**OVP HEALTH CARE, INC.
LAWRENCE COUNTY, OHIO**

FAIRLAND HIGH SCHOOL CLINIC

ADDENDUM #1

THRASHER PROJECT #T60-11686

G1.01

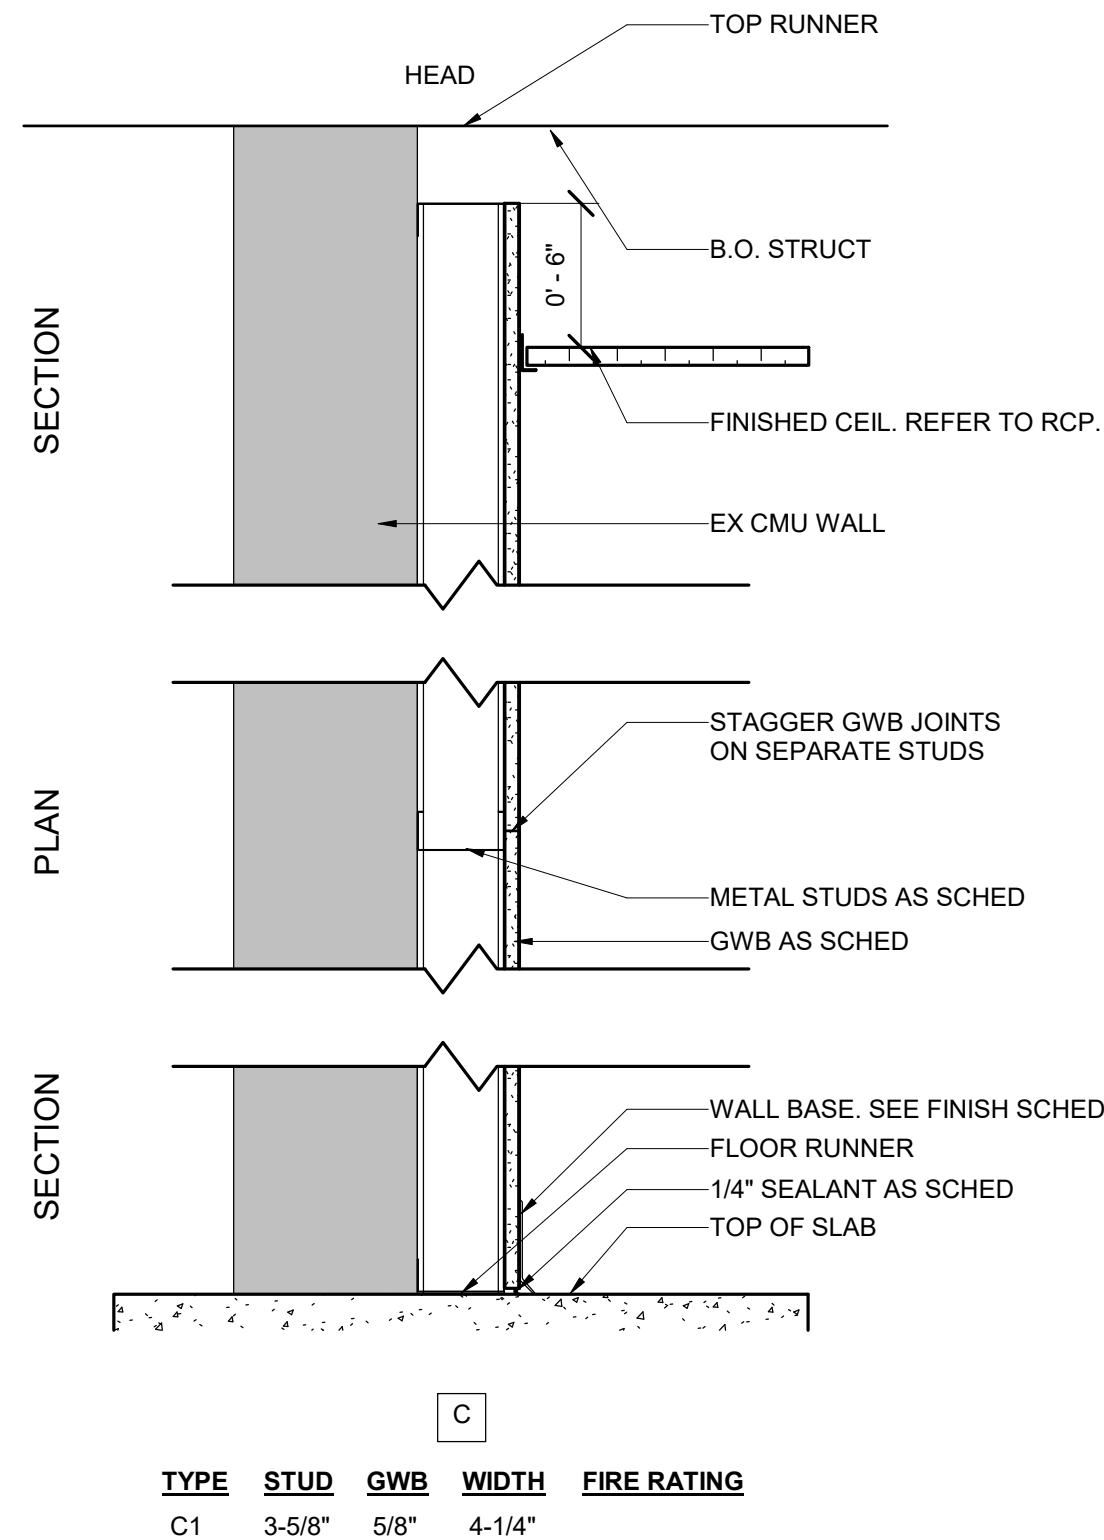
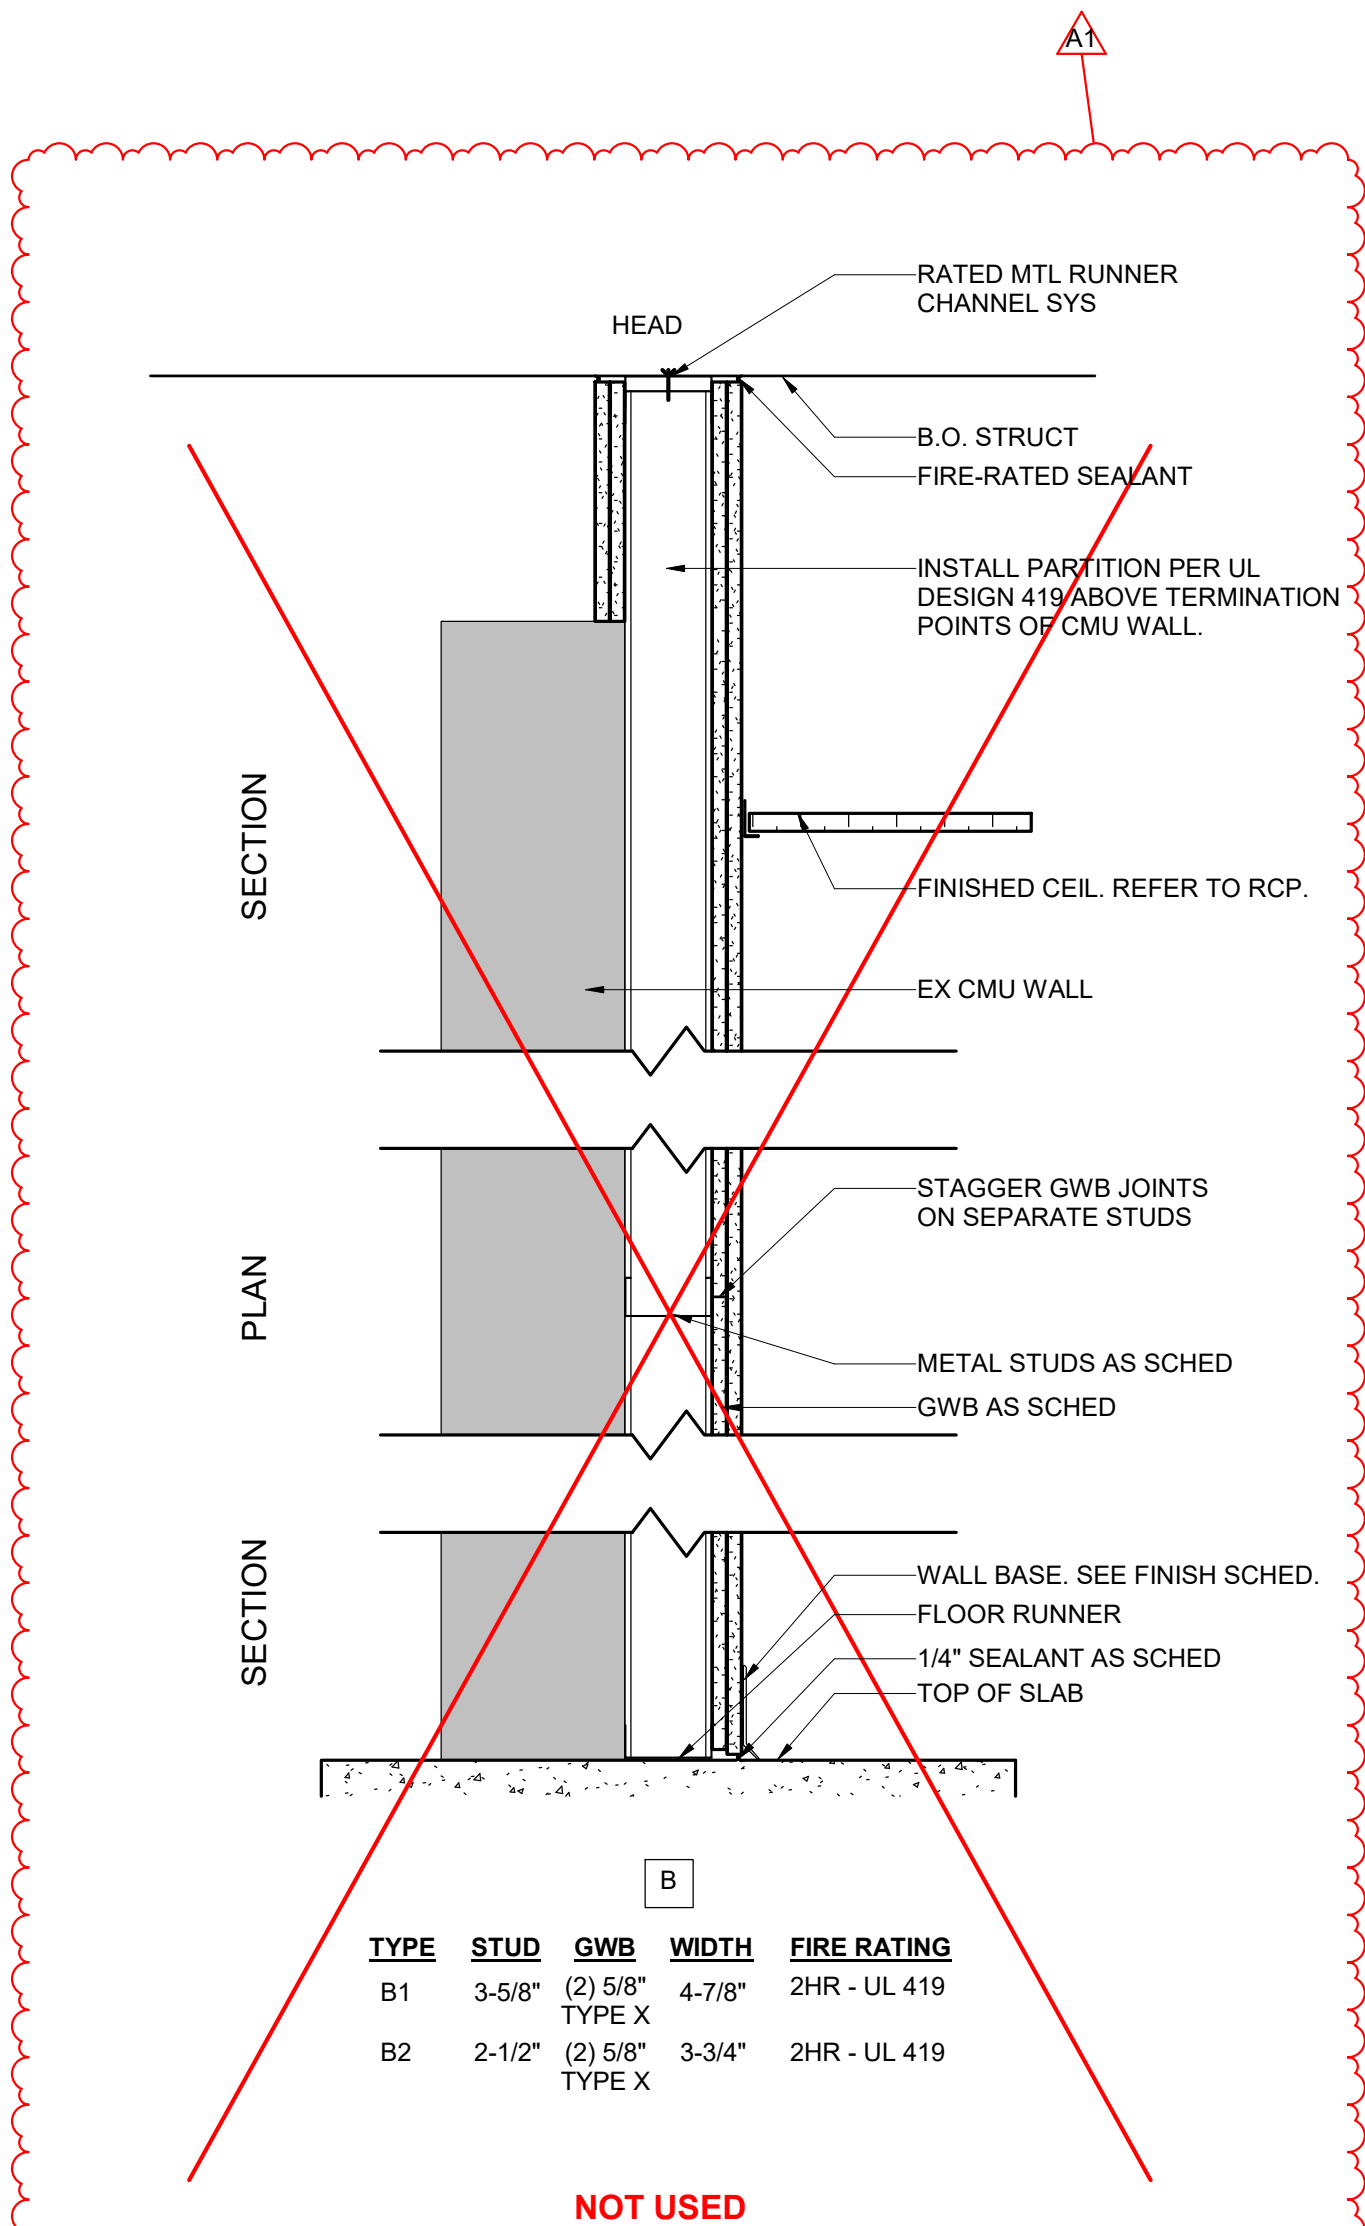
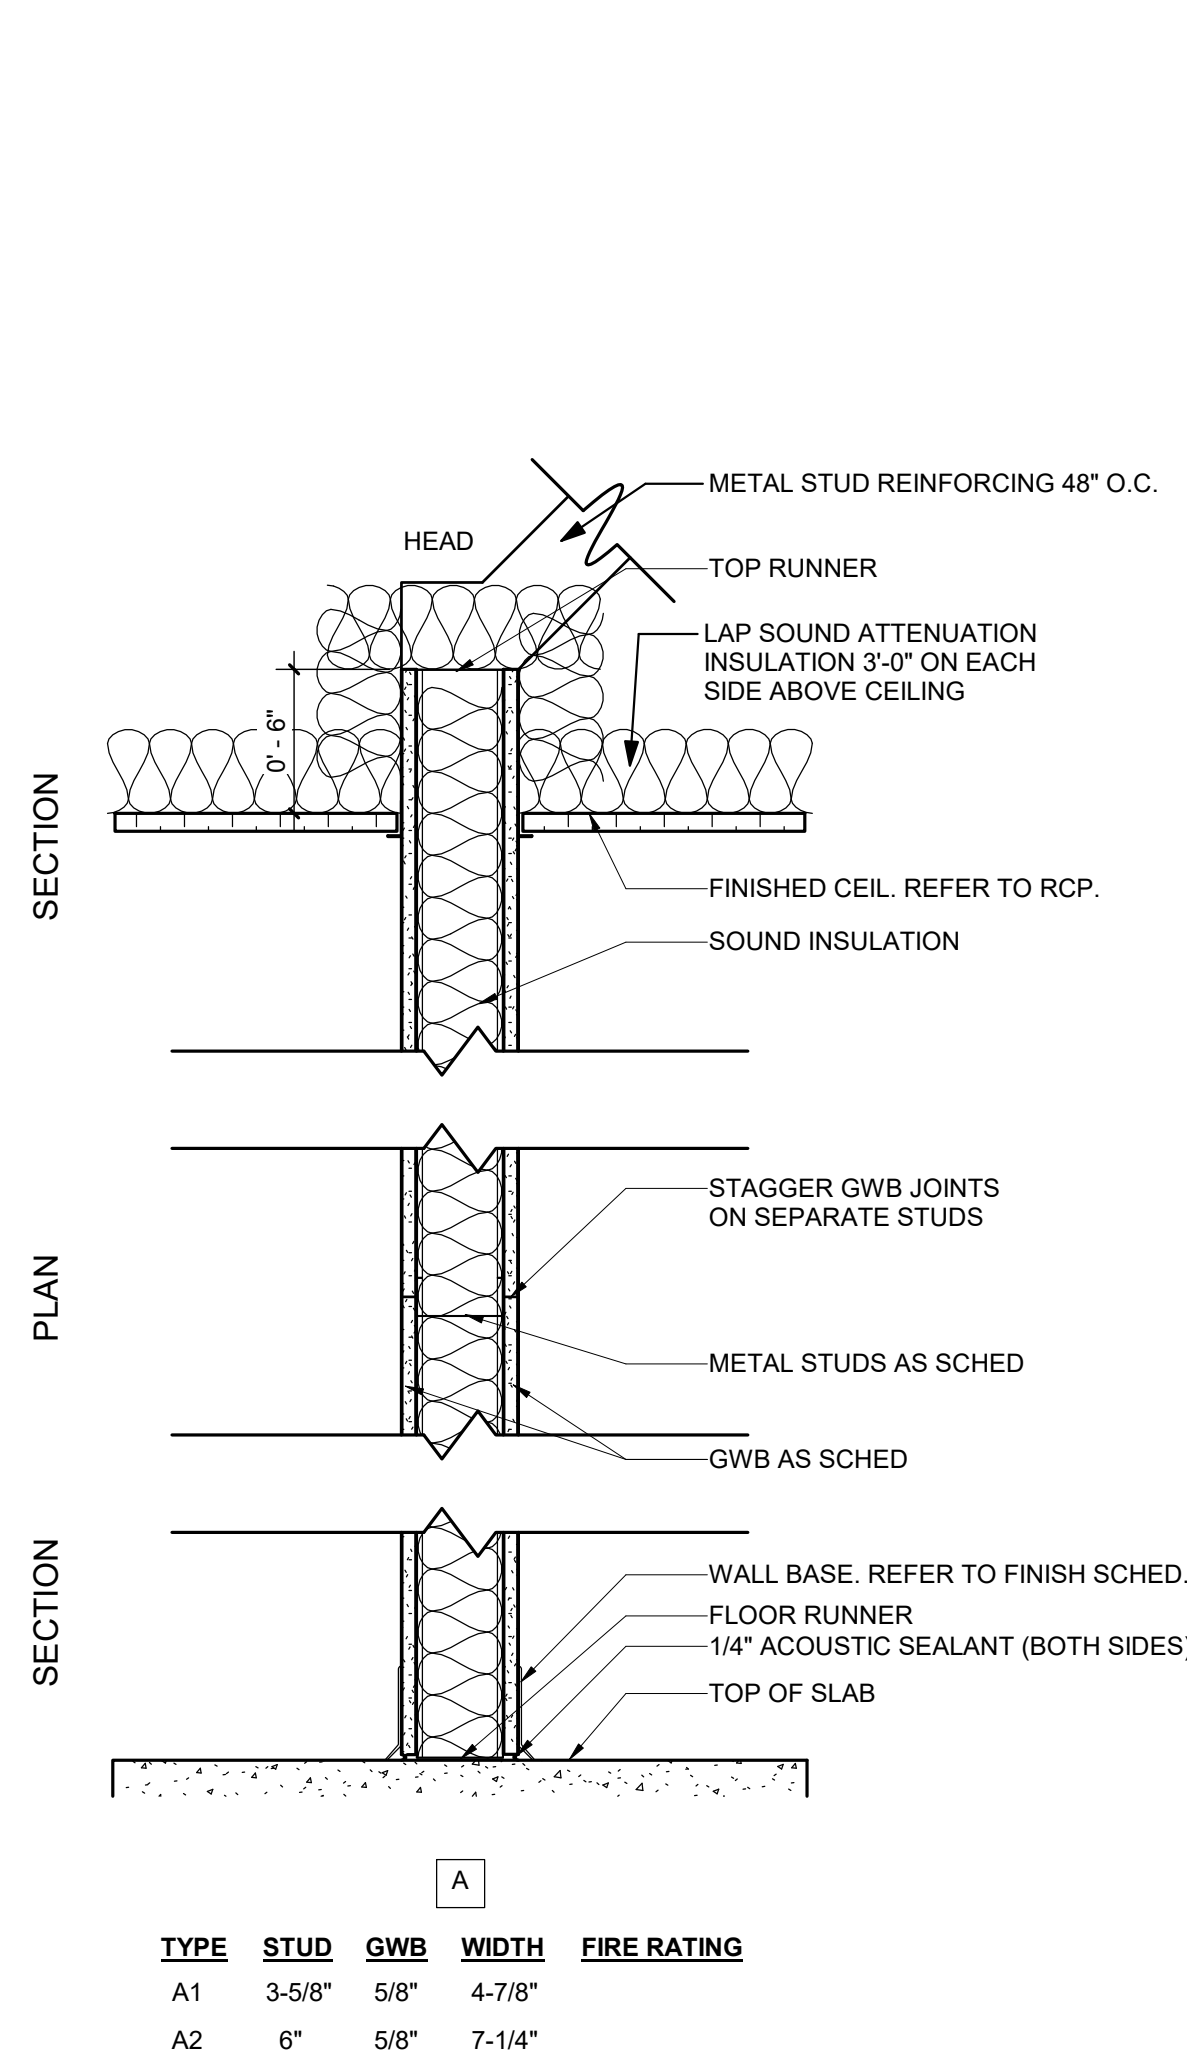
The following has been revised to remove the 2-hr fire barrier:

G1.01 has been revised.

G1.02

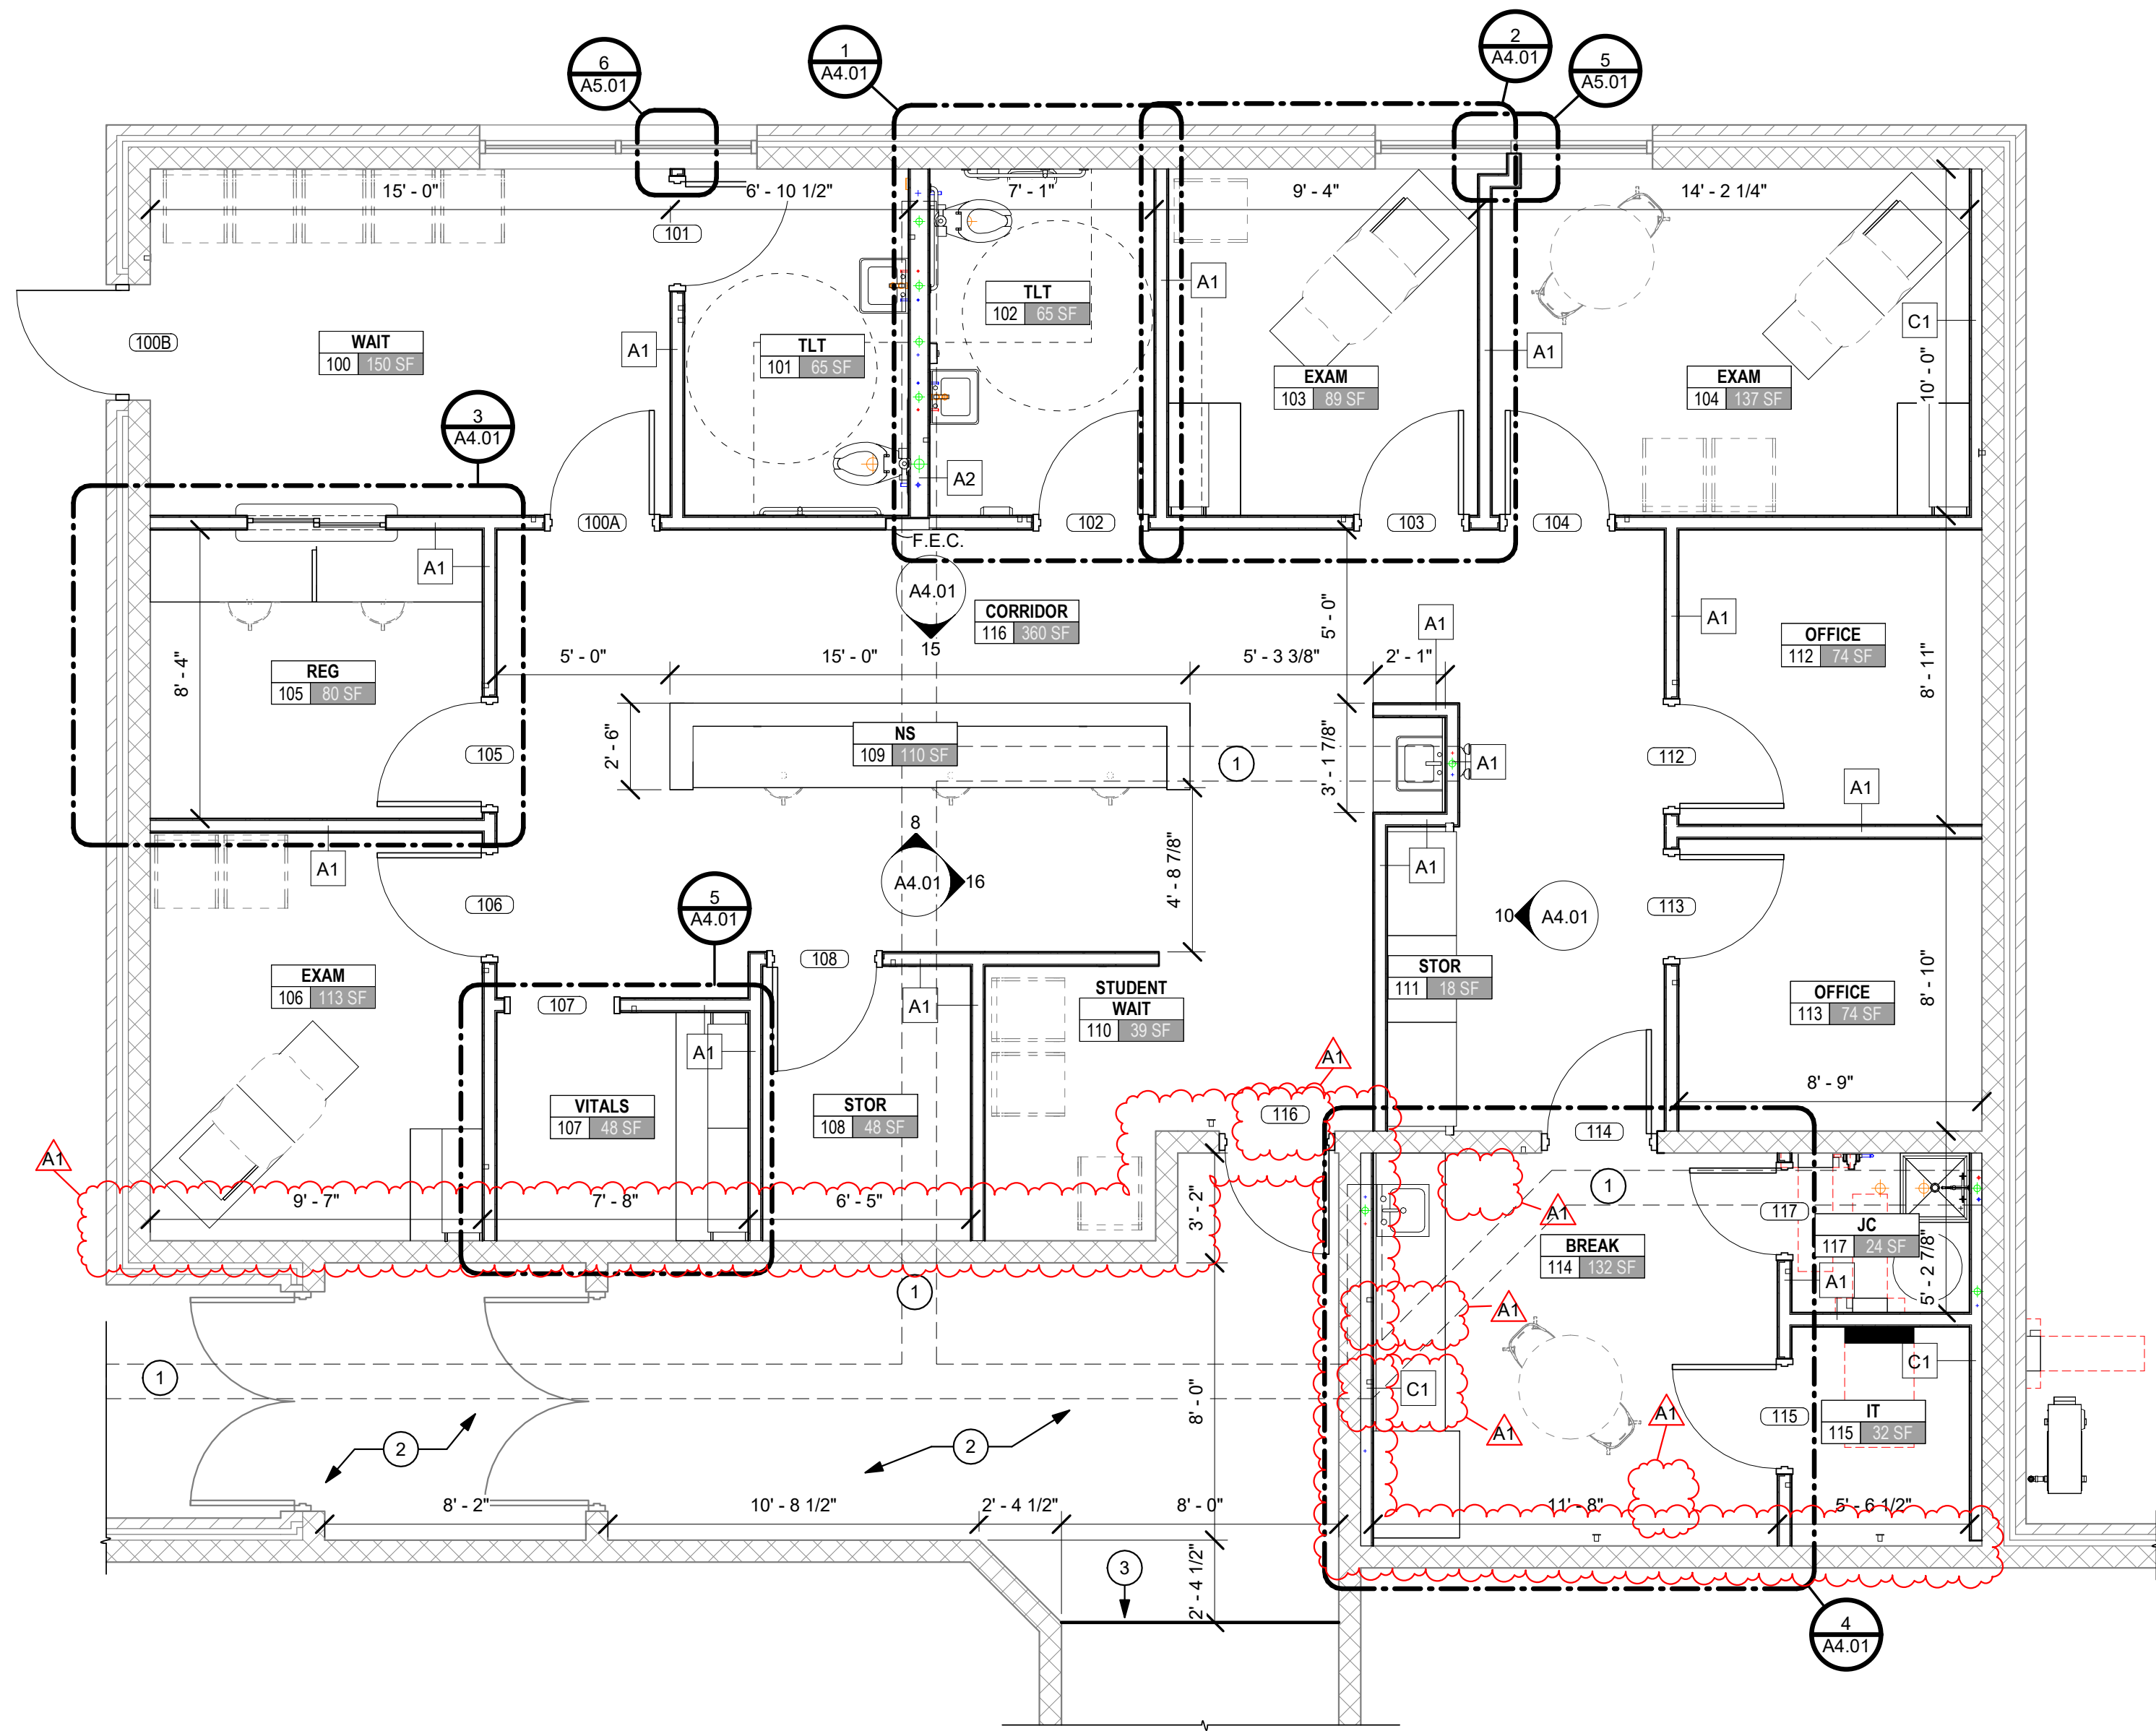
G1.02 has been revised.

A1.01

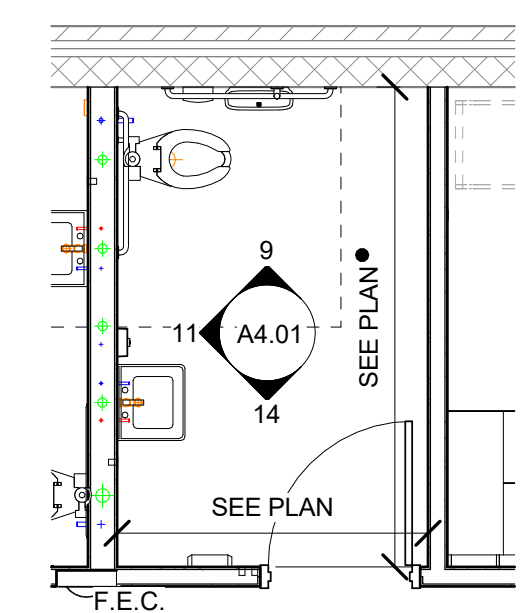
A1.01 has been revised.
